Panel Reference	PPSSNH-404		
DA Number	DA-2023/172		
LGA	Willoughby		
Proposed Development	Nominated Integrated Development (Water NSW s90 Water Management Act 2000) - SNPP - Consolidation of site, demolition of existing structures, construction of 26 storey mixed use development comprising commercial/retail, 95 residential units, publicly accessible through-site link, 4 levels of basement carparking, landscaping nad associated works.		
Street Address	44-52 Anderson Street, Chatswood		
Applicant/Owner	Grace Wu		
Date of DA lodgement	06/07/2023		
Number of Submitters	41		
Recommendation	Refusal		
Regional Development Criteria - Schedule 6 of the SEPP (Planning Systems) 2021	Development that has a capital investment value of more than \$30 million.		
List of all relevant s4.15(1)(a) matters	 State Environmental Planning Policy (Biodiversity and Conservation) 2021 State Environmental Planning Policy (Resilience and Hazards) 2021 State Environmental Planning Policy (Transport and Infrastructure) 2021 State Environmental Planning Policy (Planning Systems) 2021 SEPP No 65 - Design Quality of Residential Apartment Development and NSW Apartment Design Guide (ADG) Willoughby Local Environme

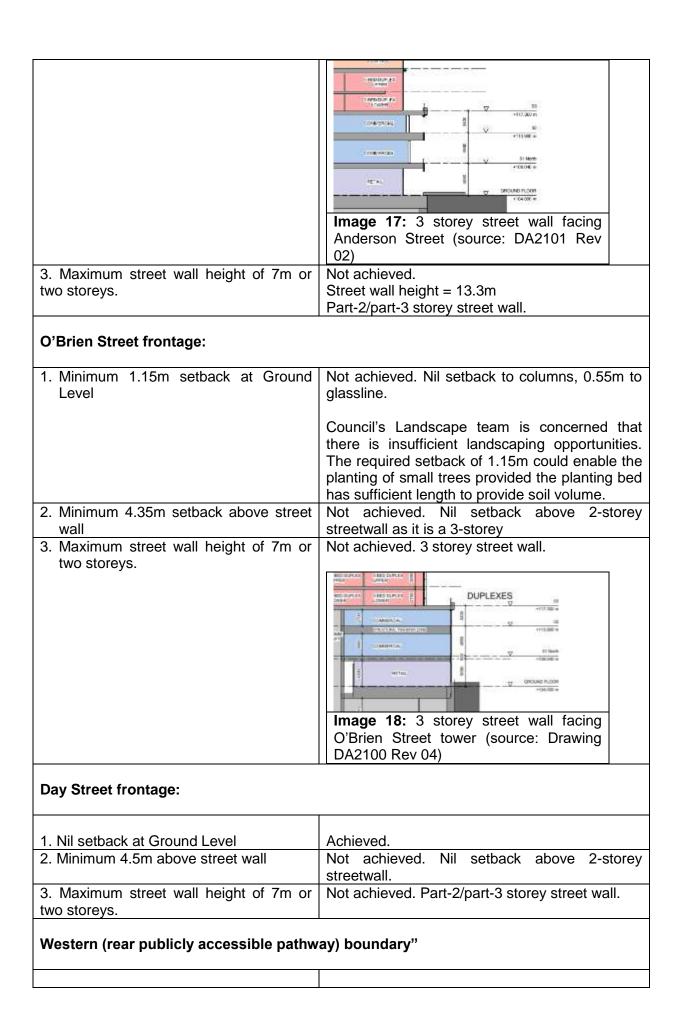
Setbacks and Street Frontage Heights	
Anderson Street frontage:	
Control	Assessment Planner response:
1. Minimum 6m setback at Ground Level	Achieved.
2. Minimum 6.4m setback above street wall	Not achieved. Nil setback above two-storey street wall. See drawing DA 2100 Rev 04 "Building Section East/West (North)".

1. Minimum 2m setback at Ground Level, with additional stepped 2m setback at Podium Level	Not achieved. 1.5m setback.
2. Minimum 7.6m setback above street wall	Not achieved. Nil setback above 2-storey streetwall.
Maximum wall height to rear pathway of 7m or two storeys.	Not achieved. Part-3/part-4 storey street wall. Image 19: Section detail east/west of the north tower (source: Drawing DA2101 Rev 02)
4. The building setbacks are to be in accordance with Map 5 below, the Setbacks and street frontage heights controls (as above) and the concept plans.	These are discussed separately below.

Image 20: Mecone's submission to Council 2 August 2024

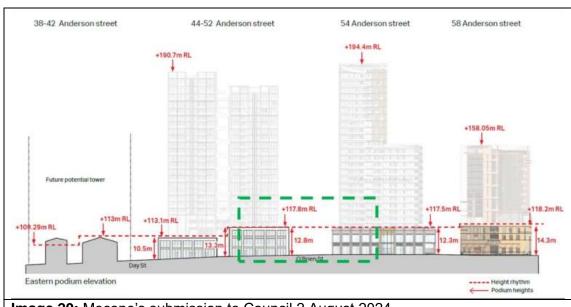
"If strict compliance with Part L [13.1.10] of the DCP was required (ie. a 2-storey podium to the north part of the site), it would result in a sub-optimal design outcome, as the ground level commercial floor would be required to be partially subterranean. This is not a desirable outcome particularly to a north façade which presents the best opportunity for activation and outdoor dining.

"It would also require more significant revisions to the scheme such as the removal of SOHO units and reconfiguration of the ground floor tenancies and access to reflect the required change in floor levels and to achieve 17% non-residential floorspace across 2 floors. It may also be necessary to omit the proposed throughsite link which would result in a development that would not align with the design competition winning scheme. This would undermine the design excellence process undertaken to-date.

"Given the circumstances of the site which falls in 2 directions, and the high quality design proposed, we respectfully request that Council excersise discretion in the application of Part L [13.1.10] of the DCP controls."

Image 21: Building Section North / South Drawing DA2100 Rev 04 (Section 1) depicts the level change between O'Brien Street and Day Street.

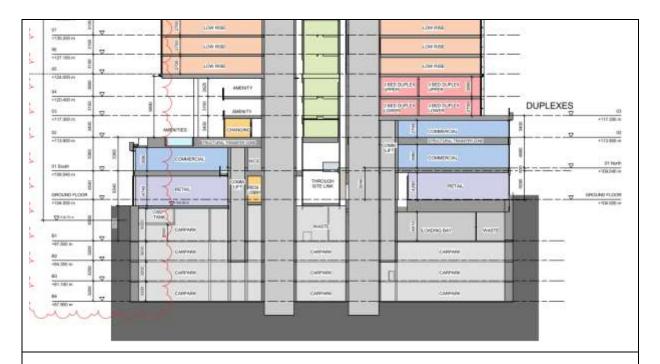
The section taken through the site (north-south) on Drawing DA2100 Rev 04 (Section 1) depicts the level change between O'Brien Street and Day Street. Drawing DA2101 Rev 02 (Section 1) depicts the level change between Anderson Street and the laneway at the rear.

The change in topography is not so compelling a reason for the stacking of commercial space in a three-storey podium. Two commercial levels could form a neat podium, the ground floor with increased ceiling heights to absorb any fall across the site to provide a satisfactory two-storey street wall height. A minimum 17% commercial floor space could still be achieved with this 2-storey commercial and through-site access.

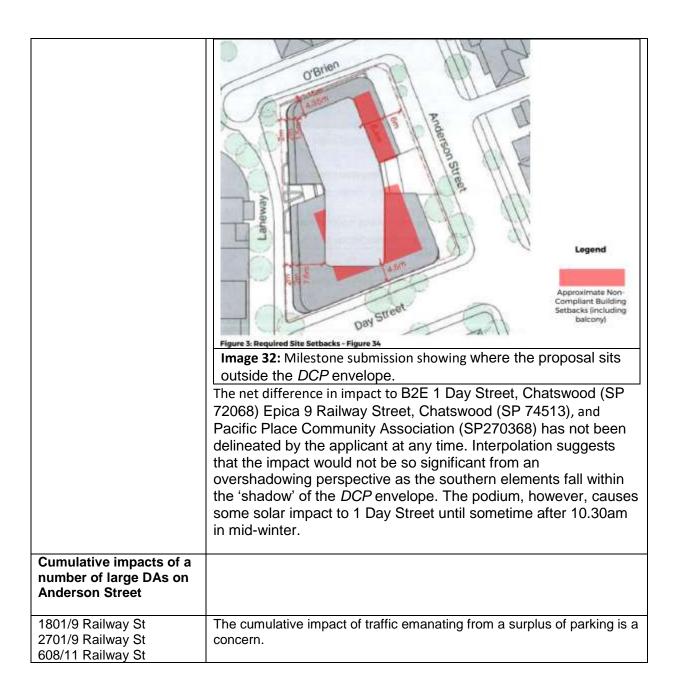
Setbacks	
Property	Assessment Planner Response
1 Day Street 9 Railway Street 716/28-30 Anderson St B2E 1 Day Street, Chatswood (SP 72068) Epica 9 Railway Street, Chatswood (SP 74513) Pacific Place Community Association (SP270368)	Requires minimum 6m setback at ground Level and minimum 6.4m setback above street wall to Anderson Street. The proposal a compliant 6m at ground level with zero setback above the street wall at some levels, 1m in others. To the rear the setback is satisfactory. The submission from Milestone (for B2E 1 Day Street, Chatswood (SP 72068), Epica 9 Railway Street, Chatswood (SP 74513) Pacific Place Community Association (SP270368) indicates where the proposal sits outside the DCP envelope.
